Reference: **DCI2019-00019 - AMAVIDA RPD**
Hearing Date: February 5, 2020
Applicant’s 48-hour Notice and Exhibit List

Lee County, Florida
DEPARTMENT OF COMMUNITY DEVELOPMENT
ZONING SECTION
STAFF REPORT

CASE NUMBER: DCI2019-00019

CASE NAME: AMAVIDA RPD

DCI2019-00019 Future Land Use

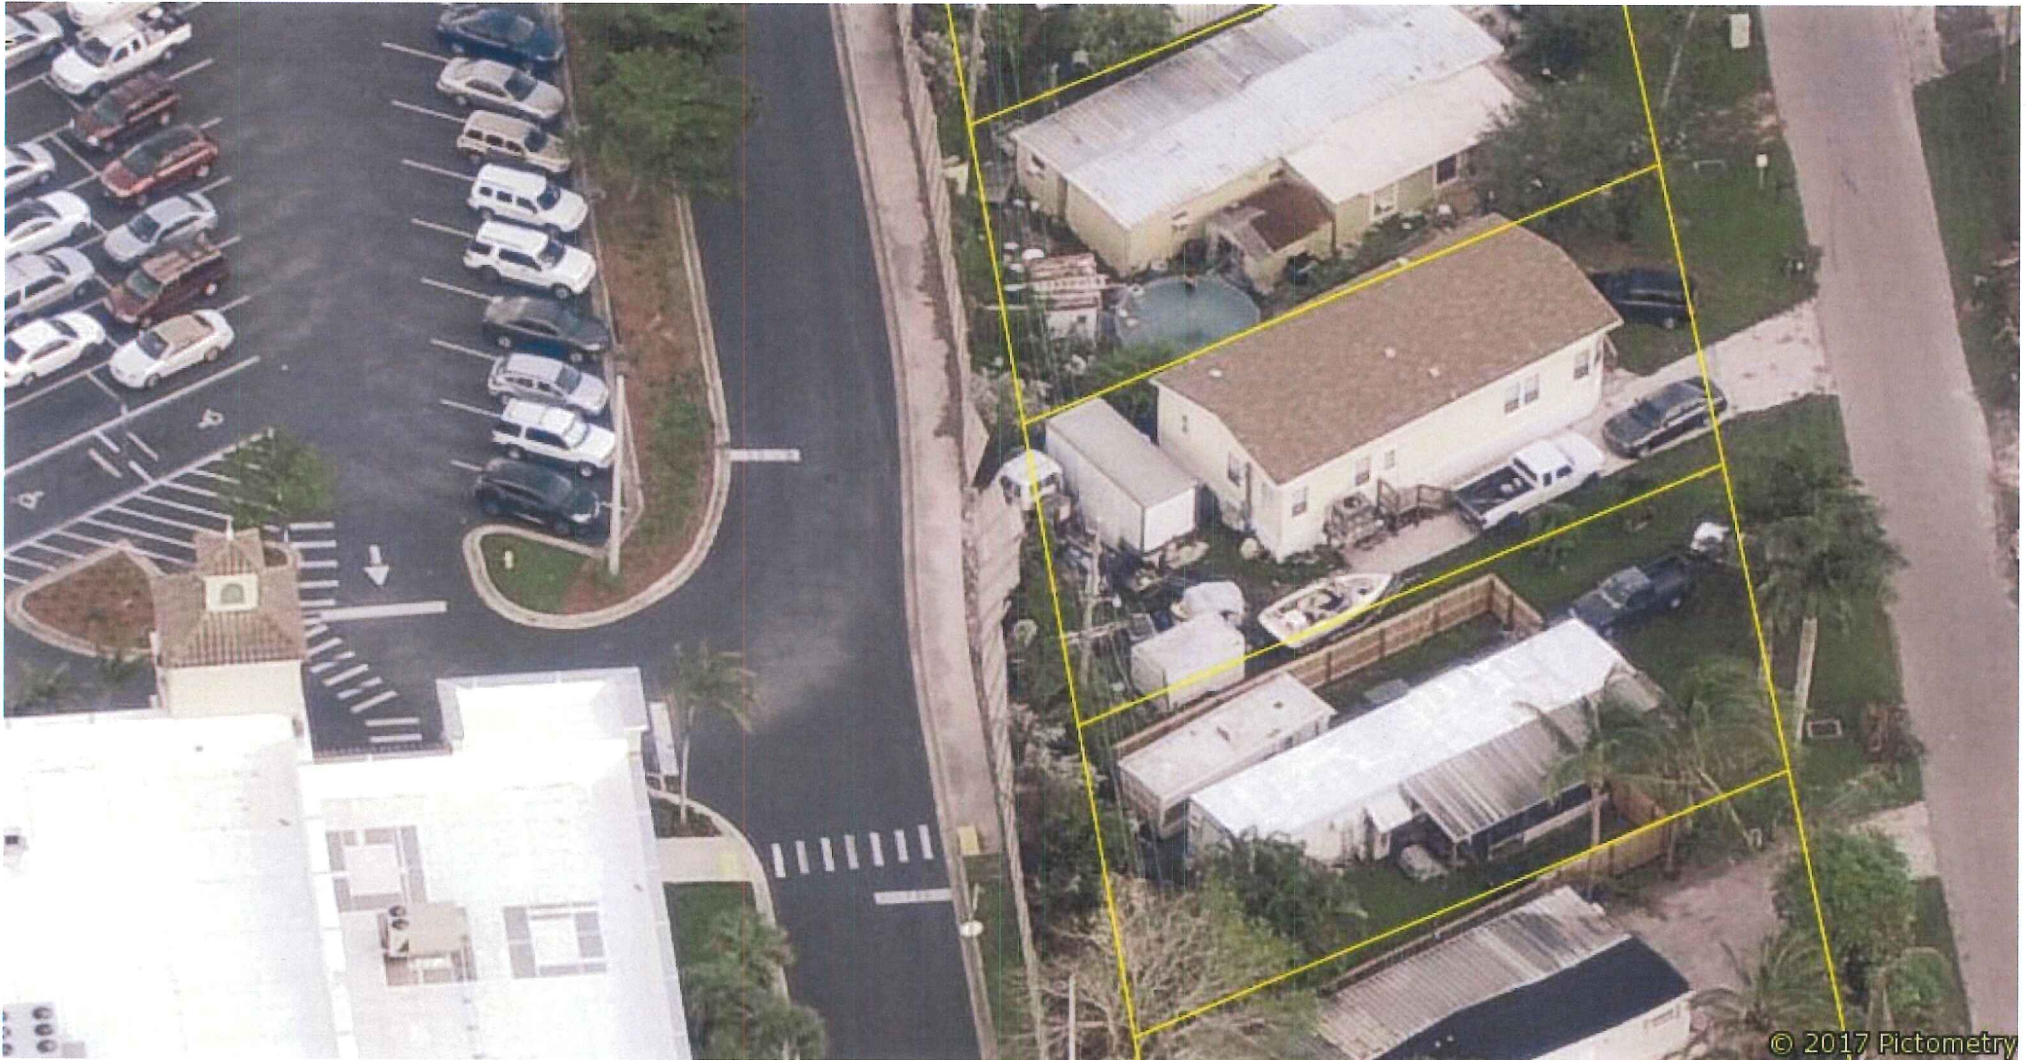
- Page 15 of PDF, after FLUM-There is a post Irma photo that was inadvertently attached and should be discarded
- Attachment C-Staff conditions:
 - Page 1, A.1., 3rd paragraph, 1st line:

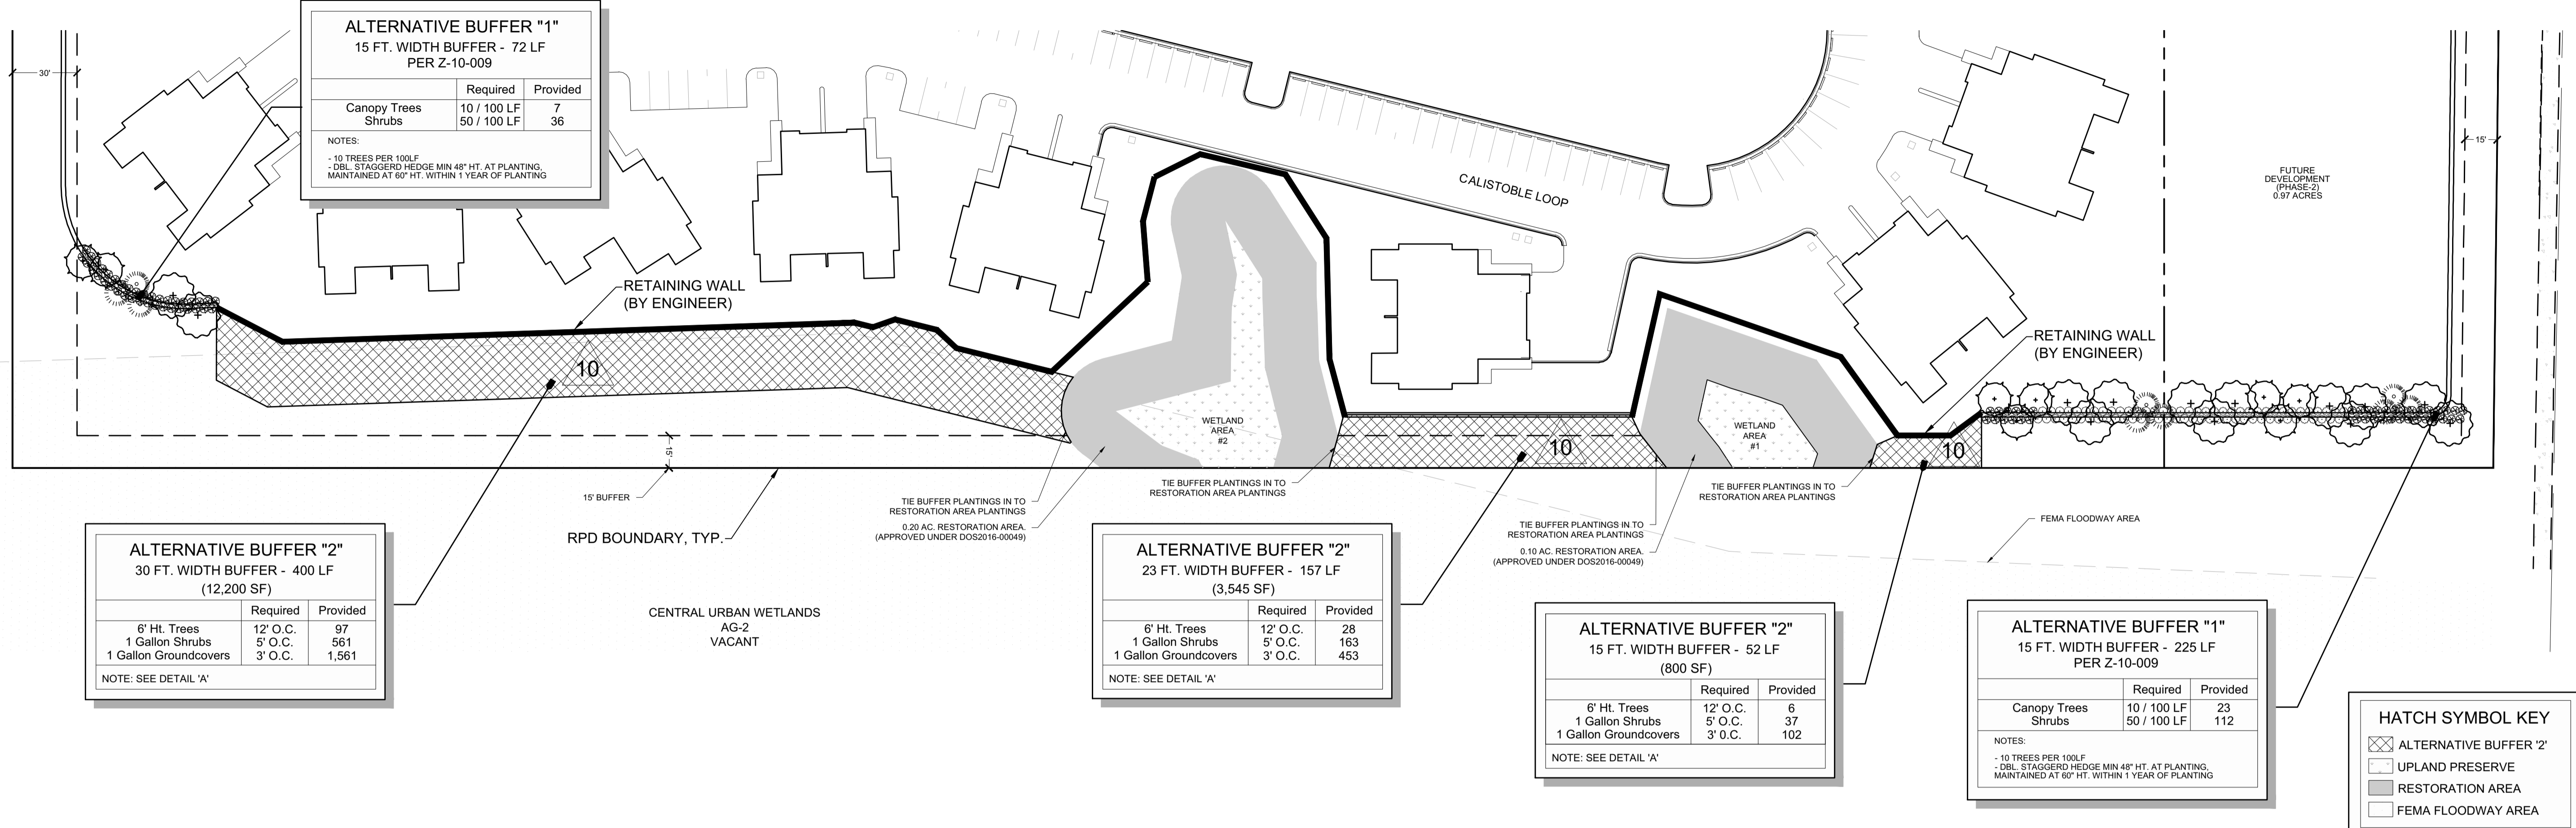
- Page 10 – Deviation 11 condition ii.: Revise Exhibit from B to “H”
- Clean Versions of proposed Exhibits D, E, F, G & H referenced in the proposed conditions are attached.

- i. Prior to development order approval, the western buffer must illustrate 131 trees installed at a height of six feet, 761 shrubs installed at a height of 24 inches and 2,116 one gallon groundcovers. All plant material must be salt tolerant and native species.
- ii. The development must be substantial compliance with Exhibit ~~B~~^H, dated May 23, 2018.
